Liz Knitting & Printing Industry (Extension)

Structural Inspection Report

LKP-3 Building: Five-storied (G+4) concrete building

Connecting Bridge: Single-storied steel connecting bridge

Observation 1: Prepared design documents to be reviewed for lateral forces. (LKP-3 Building)

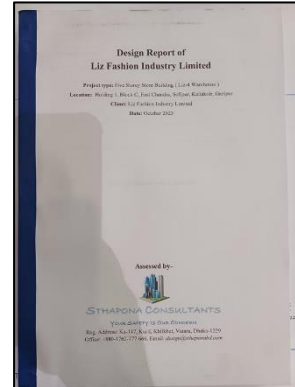
Description: A set of design documents was available onsite which are to be submitted to RSC for detailed review against lateral forces. Revise the design documents based on in-situ material strength. Submit the design documents to the RSC for review.

Item No	Observation	Action Plan	Timeline
1.	Prepared design documents to be reviewed for lateral forces. (LKP-3 Building)	The building engineer is required to submit the design documents to the RSC for detail review against wind & seismic forces.	within 6 weeks

Observation 3: Lack of floor load management program (LKP-3 Building)

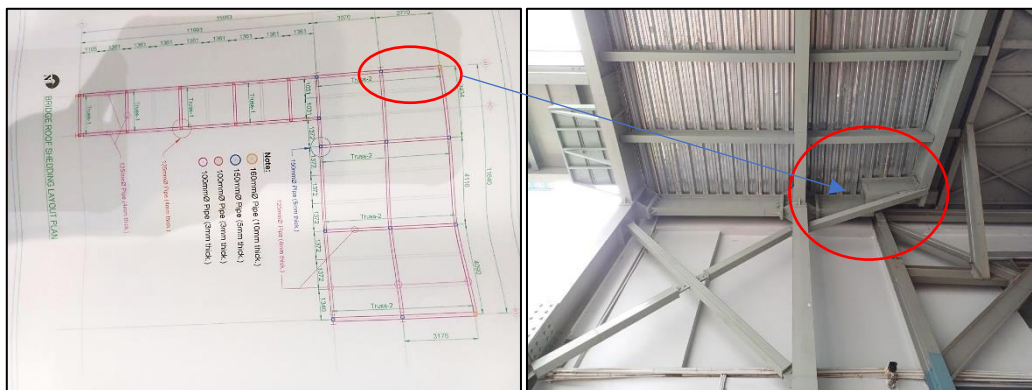
Description: Load plan was prepared for all floors but was not posted on all floor levels.

4.		Carry out remedial work if required.	within 6 months
5.	Lack of floor load management program (LKP-3 Building)	Implement floor load management program ((posting load plan, marking area & height, and maintaining floor loading)).	within 6 weeks
